New Albany Planning Commission Agenda

Monday, November 20, 2023 7:00pm

Planning Commission Staff Report October 16, 2023 Meeting

CHIPOTLE FINAL DEVELOPMENT PLAN AMENDMENT

SHEET
FIRE TRUCK TURNING

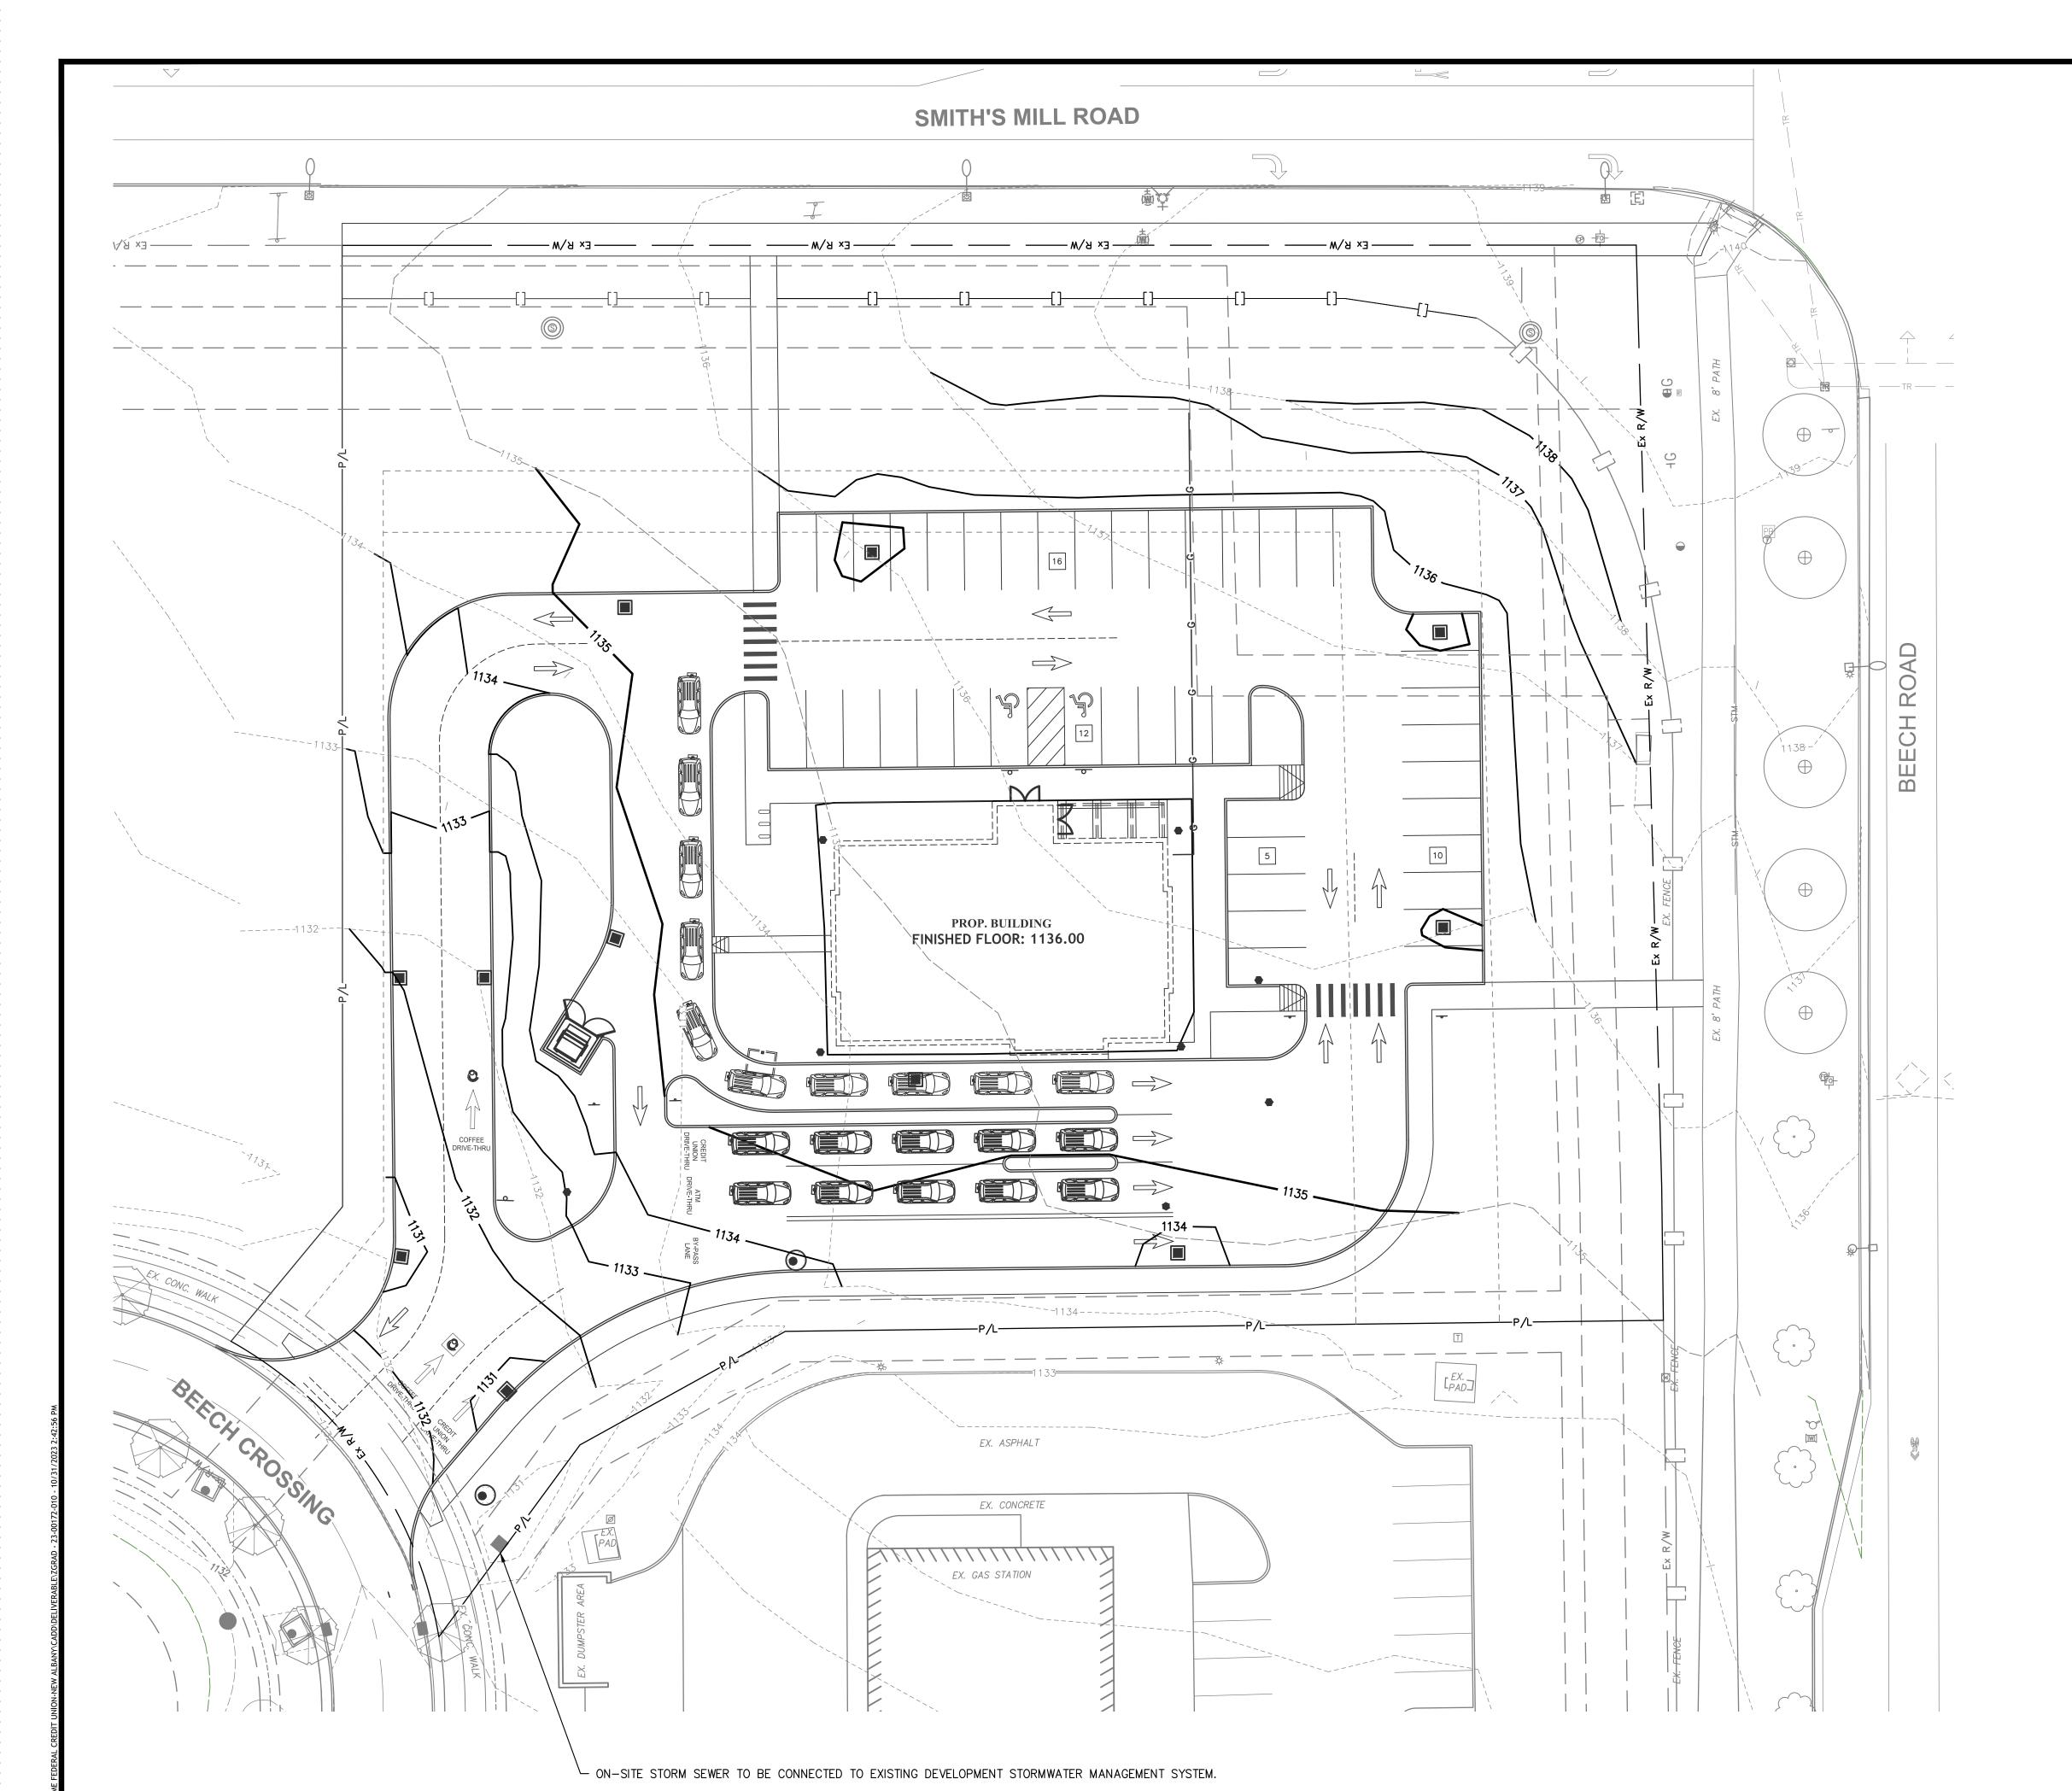
- 2. Refer to sheet C1.01. Show the location of the stop bar and stop sign at the curb cut and provide a cross walk and signage that meets ADA requirements.

- 3. Refer to Exhibit B. Revise sheet C1.01 in accordance with this Exhibit. Consider mountable curb where concrete curb is proposed.
- 4. Refer to sheet L1.00. Provide a site distance triangle at the Beech Crossing curb cut and evaluate site distance relative to existing and proposed landscaping. Remove landscaping that may impede motorist view.
